RICHMOND BOROUGH COUNCIL

PROOF OF EVIDENCE

**Arlington Works
23-27Arlington Road
Twickenham
London
TW1 2BB**

18/2714/FUL

Figure 5: Highway Boundary East of the Access to the Proposed Development (London Borough of Wandsworth, 2020)

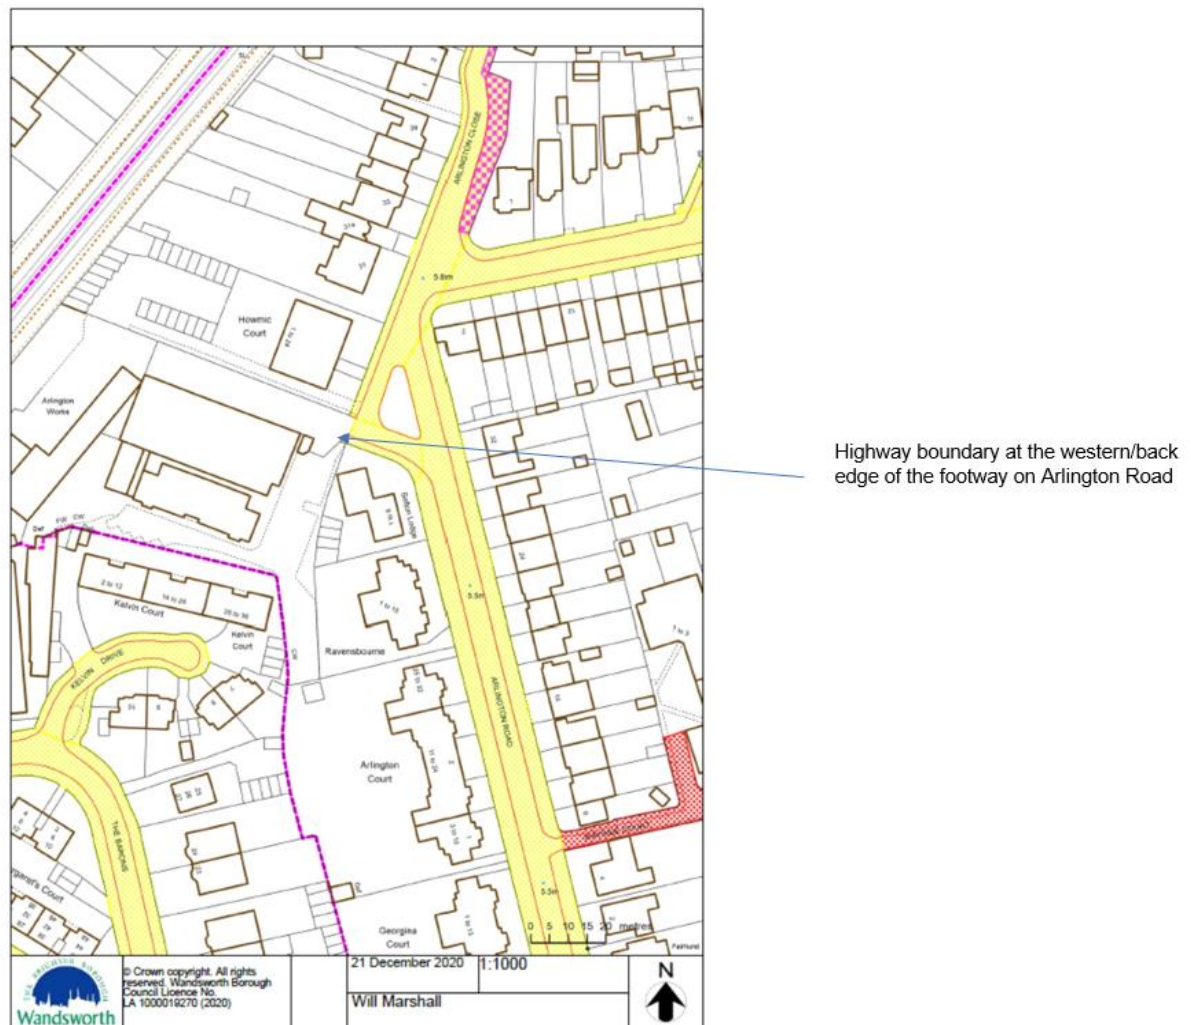
5.1 To access the development, occupants will have to use an existing shared space private access road which is itself accessed from the western side of Arlington Road via a bell-mouth access that is 4m wide. The photograph provided as Figure 4 overleaf shows the access looking westwards from Arlington Road. I have attached a plan showing the highway boundary on Arlington Road in relation to the site access as Figure 5. The highway boundary would appear to be that the back edge of the footway on the northern and southern side of the site access.

Figure 7: Proposed Site Access Layout Plan submitted by the Appellant but with the Author's Annotations

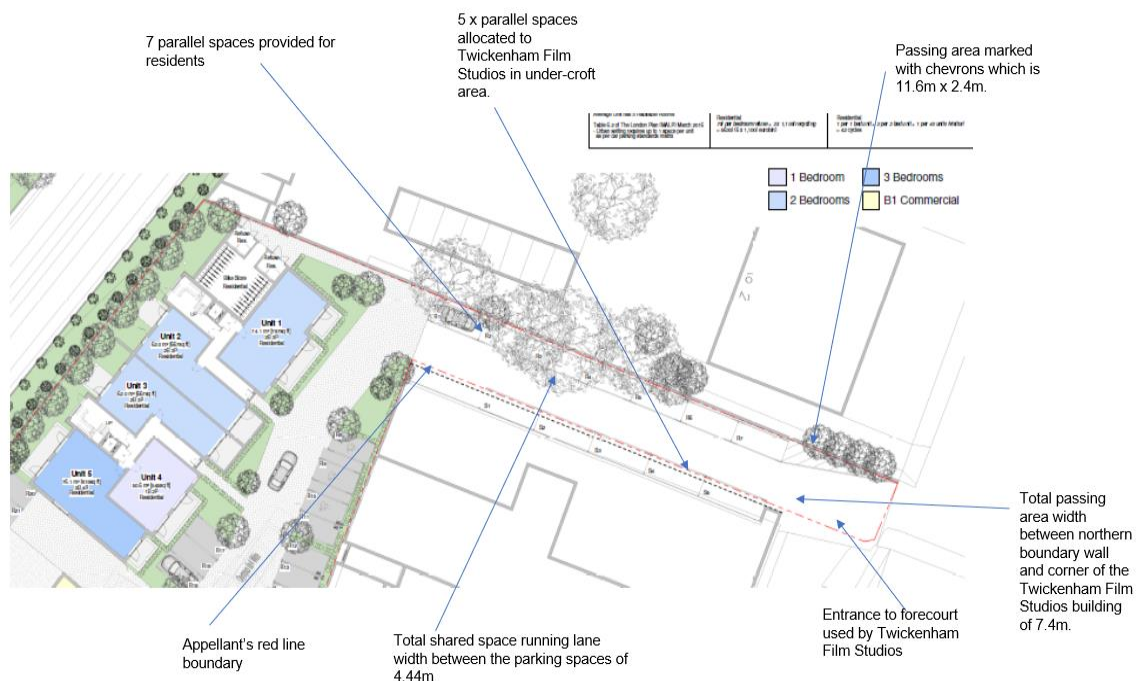
5.3 There is a total width of 9.44m between the northern boundary wall and the back wall of the under-croft parking area to the south. The appellant proposes to utilise all of this to provide 7 parallel parking bays on the northern side of the access road, which would be allocated to residents, 5 parallel parking bays on the southern side of the access road which would be allocated to the Twickenham Film Studios, and a shared space running lane width between the two rows of parked cars for all road users which will be 4.44m in width. I attach a copy of the proposed ground floor site plan which the appellant submitted with their planning application, but with my annotations added, as Figure 7 overleaf:

5.4 Figure 8.18 of *Manual for Streets* (Department for Transport, 2007), which I have attached as Appendix K of this document, suggests that inset parallel parking bays should be a minimum of 6m x 2m. However, because both rows of parking spaces will be enclosed by a wall on one side, I consider that parallel spaces in this case need to be a minimum of 6m x 2.5m to allow the nearside car doors of large cars, like the one used in Appendix F of the appellant's Transport Statement, parked on either side of the road to be opened safely. If the appellant failed to provide parallel spaces wide enough to allow motorists to open their car doors without fear of damaging them on the walls that enclose the spaces on one side or stepping into a muddy unsurfaced area as they got out of their vehicles on the northern side of the access road, motorists could be forced to look for car parking spaces on surrounding streets that are part of the CPZ, thereby adding to already high levels of vehicular parking stress. They could also be forced to park in areas of streets with single yellow line restrictions on the highway, thereby inhibiting the safe movement of vehicular traffic, or could be forced to park informally within the proposed development which is also a shared space area. If motorists were to park vehicles parallel to the grass verges within the proposed development, this would

be likely to cause pedestrians to walk in the middle of the shared space area and come into conflict with HGVs that need to service the site such as refuse vehicles or delivery trucks. Motorists might also be forced to park in the area allocated as a turning area for service vehicles north-east of Unit 22, thereby preventing safe and suitable access to the development for refuse and emergency service vehicles. Para. 7.2.13 of *Manual for Streets* points out that one of the problems that must be avoided, in order to provide a safe environment for all road users, is the “undifferentiated surfaces leading to poor parking behaviour.” The proposed development is therefore contrary to Para. 108b of the NPPF.

5.5 Were 2.5m width on each side of the access road to be allocated to provide the parallel parking spaces proposed, this would leave a shared space width of 4.44m for all road users to access and egress the proposed development. Table 6.1 of the appellant’s transport statement shows that the residential land use within the development will create up to 3 vehicular and 8 pedestrian trips in the AM weekday peak hours and up to 4 vehicular trips and 6 pedestrian trips in the PM weekday peak hour, a person trip rate of 1 trip per 9-10 minutes. In addition to this, the appellant stated that there will be an average of four two-way delivery trips per day for the residential land use and two two-way delivery trips per day for the B1 land use. Employees of the proposed 610m² gross internal area floorspace of B1 commercial land use will generate up to 2 vehicular trips at the AM and PM weekday peak hours because of the proposed number of parking spaces provided for this land use within the development. It is not clear how many pedestrian trips the proposed B1 land use would create at the AM and PM weekday peak hours. However, the table in Section 6 of the *Employment Density Guide* (Homes and Communities Agency, 2015) (3rd Edition) that I have attached as Appendix L of this proof, indicates that the proposed B1 commercial floorspace will employ up one full-time equivalent employee (FTE) per 12-60m² net internal area floorspace, depending on what B1 category is used. Therefore, between 8 and 41 FTE employees are likely to access the proposed B1 land use per working day and between 6 and 39 of them will need to walk in and out of the site. Therefore, for example, up to 39 pedestrians egressing the development at the PM weekday peak hour could conflict on the shared space access road with four motorists who are residents driving home into the development from work. This is likely to lead to

5.6 The appellant proposes a shared space access road width between the two proposed rows of vehicles parked parallel to the northern and southern boundary walls of the site of 4.44m. Figure 7.1 of *Manual for Streets*, which I have provided as Appendix N of this document shows that this exceeds the 4.1m running lane width needed to allow a rigid HGV of 2.3m in width to pass a pedestrian or cyclist and to allow two cars to pass each other. However, the appellant has not provided a running lane width which is wide enough to allow a car to pass a rigid HGV or a refuse vehicle or 2.5m in width. As set out on the annotated site plan in Figure 7, the only place at which HGVs can pass cars is the area marked out by and to the south of the marked out chevrons on the northern side of the access road west of the site access which is 11.6m long and 7.4m wide. The appellant has not provided a vehicle tracking drawing which showed that a refuse vehicle of 10.4m x 2.5m could pass a car safely at this point with the eastbound or egressing vehicle having a safe clearance length to enable them to manoeuvre in and out of the passing bay marked with chevrons in forward gear without colliding with vehicles parked on the northern side of the road or the northern boundary wall. There is no minimum

design standard for a passing place or refuge within a mixed-use development of this type, but it should be at least twice the length of the largest vehicle it is likely to accommodate. The lack of appropriate clearance at this passing point is likely to lead to vehicles reversing long distances along the access road in a westerly direction where they would be more likely to conflict with non-motorised users. Failure to provide a passing place for motor vehicles of adequate dimensions on the proposed access road is likely to lead to vehicles having to reverse long distances back into the proposed development, which is likely to increase the likelihood of collisions between reversing vehicles and other road users, and is also likely to force vehicles entering the proposed development in a westerly direction to reverse back on to Arlington Road east of the proposed access, increasing the risk of collisions between these vehicles and other motor vehicles using the carriageway on Arlington Road. As the photograph in Figure 4 shows, this part of Arlington Road has two footway CPZ bays and a carriageway width between parked vehicles and the verge to the north of 3.6m. The proposed development is therefore contrary to Para. 108b of the NPPF.

5.10 As set out in Figure 7 and Appendix C, the appellant intends to provide five vehicular parking parallel vehicular parking spaces for use by employees of Twickenham Film Studios in an area immediately south of the red line boundary of their site. They require this arrangement to be able to provide their shared space access road running lane width of 4.44m. I have attached the Land Registry Title Plan for Title Number SGL280384 and the accompanying document as Appendix Q of this document. This shows that the appellant has an area of approximately

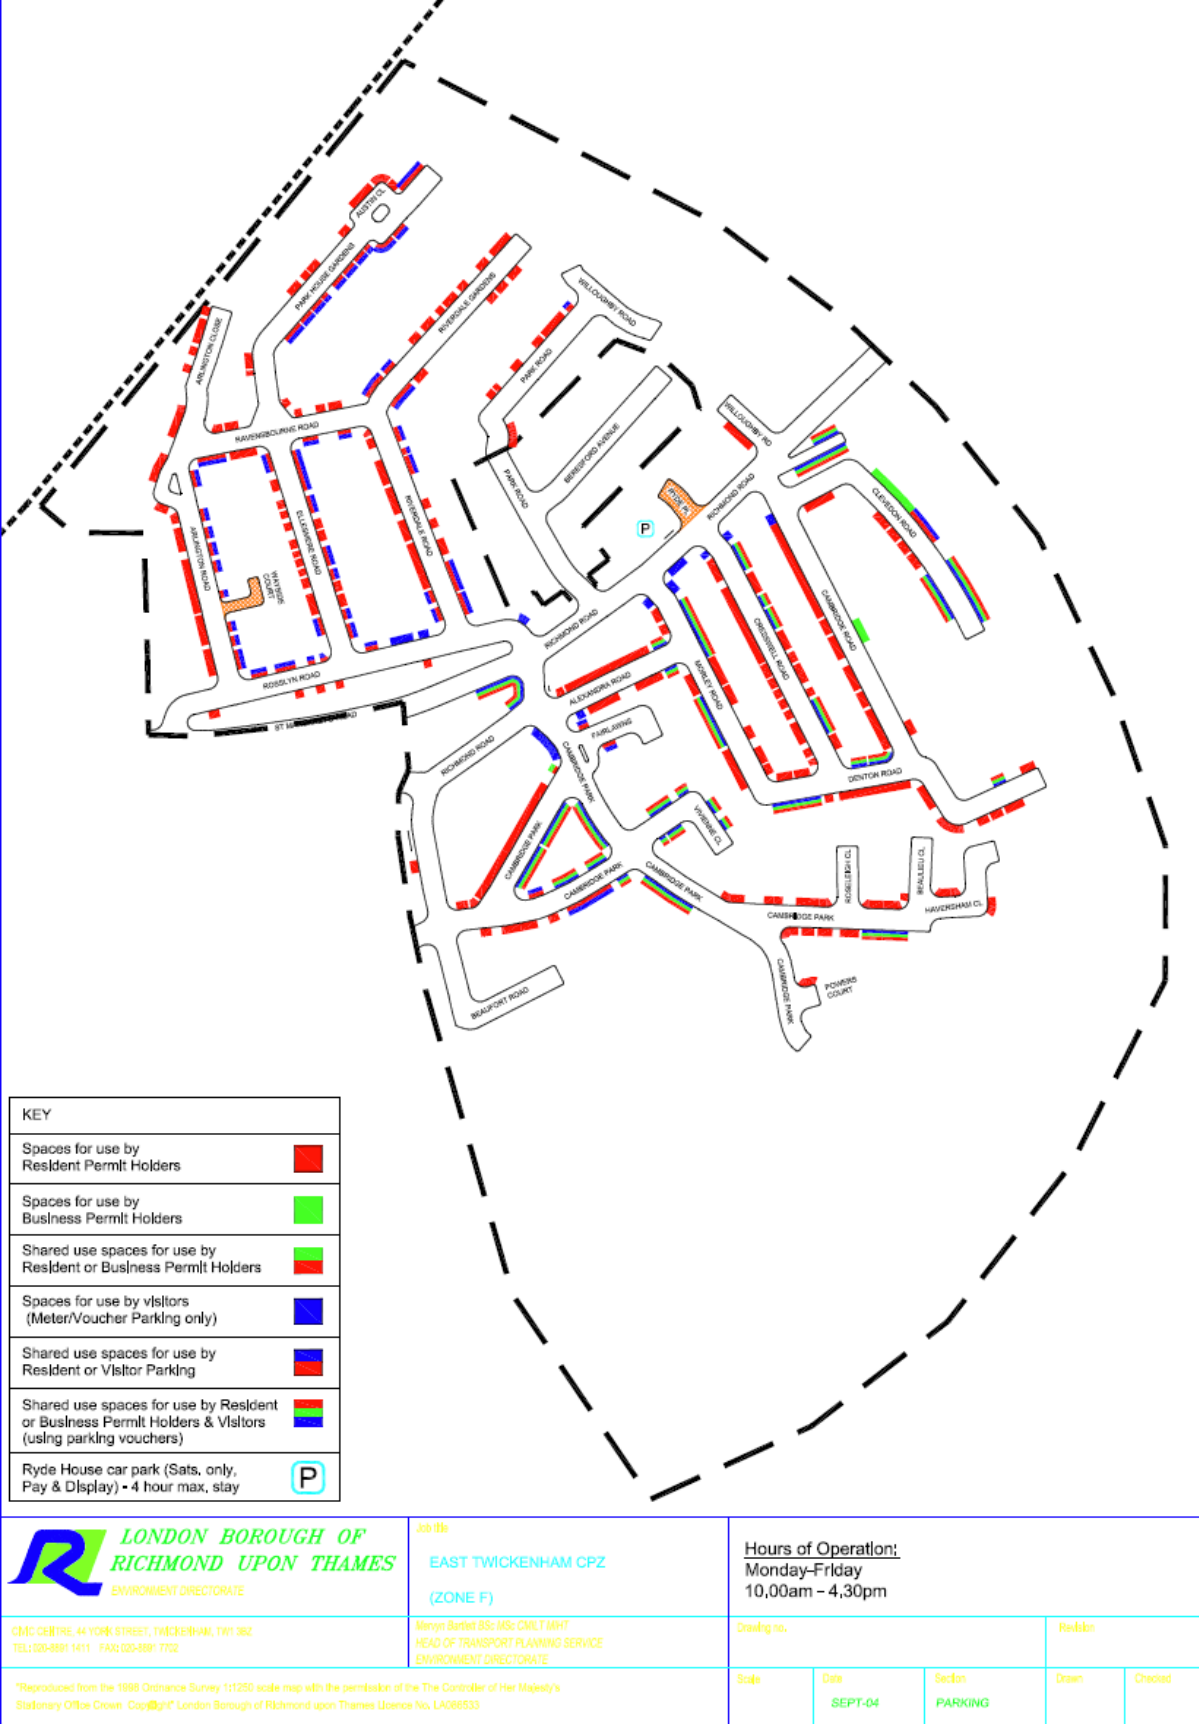
7.4 The appellant proposes a shared space private access road as set out in Appendix C and Figure 7 of this document. This is 53m long and is enclosed by boundary walls on both its northern and southern sides. The appellant proposes parallel parking bays along its entire length apart from a length of 11.6m just west of its access on to Arlington Road. West of this area the access road has a total width of 9.44m between the two boundary walls. The appellant proposes to mark out parallel parking bays which would need to be 2.5m wide to allow motorists to open nearside car doors safely, giving a total running lane width for all road users of 4.44m. This is below the minimum required safe width of 4.8m which would allow a car to pass an HGV safely as set out in Fig. 7.1 of *Manual for Streets*. The appellant has not provided a vehicle tracking drawing to show that vehicles can use the proposed passing area safely. This is likely to lead to motorists reversing long distances which would bring them into conflict with other road users in the development or on the highway. The proposed development is therefore contrary to Para. 108b of the NPPF because the appellant has not demonstrated that they can provide safe and suitable access to the development for all road users. I ask that the appeal is dismissed because of this.

7.5 The layout of the shared space access road with parking bays either side of it and a running lane width of 4.44m is likely to be difficult to use for blind or partially sighted pedestrians because they will not have a wall or building line to act as a guide. Other vulnerable road users such as parents with small children would find the road difficult to use because of the lack of refuge or separation from vehicular traffic. The proposal is therefore contrary to Para. 108b of the NPPF because it does not provide safe and suitable access to the development for disabled and vulnerable road users.

7.6 The appellant's own vehicle tracking drawings show that a refuse vehicle of 10.4m x 2.5m would not be able to enter, turn in, and exit the development in forward gear without coming into conflict with parts of the public realm in the development. This

could lead to refuse collectors reversing the vehicle 53m along the access road, in a westerly direction, to a point east of the bend described in Section 5 and carrying/dragging bins up to 50m to the vehicle. My concerns on this point could be met if the appellant agreed to service the development with a smaller refuse vehicle, possibly provided by a private contractor. This could be secured via a planning condition.
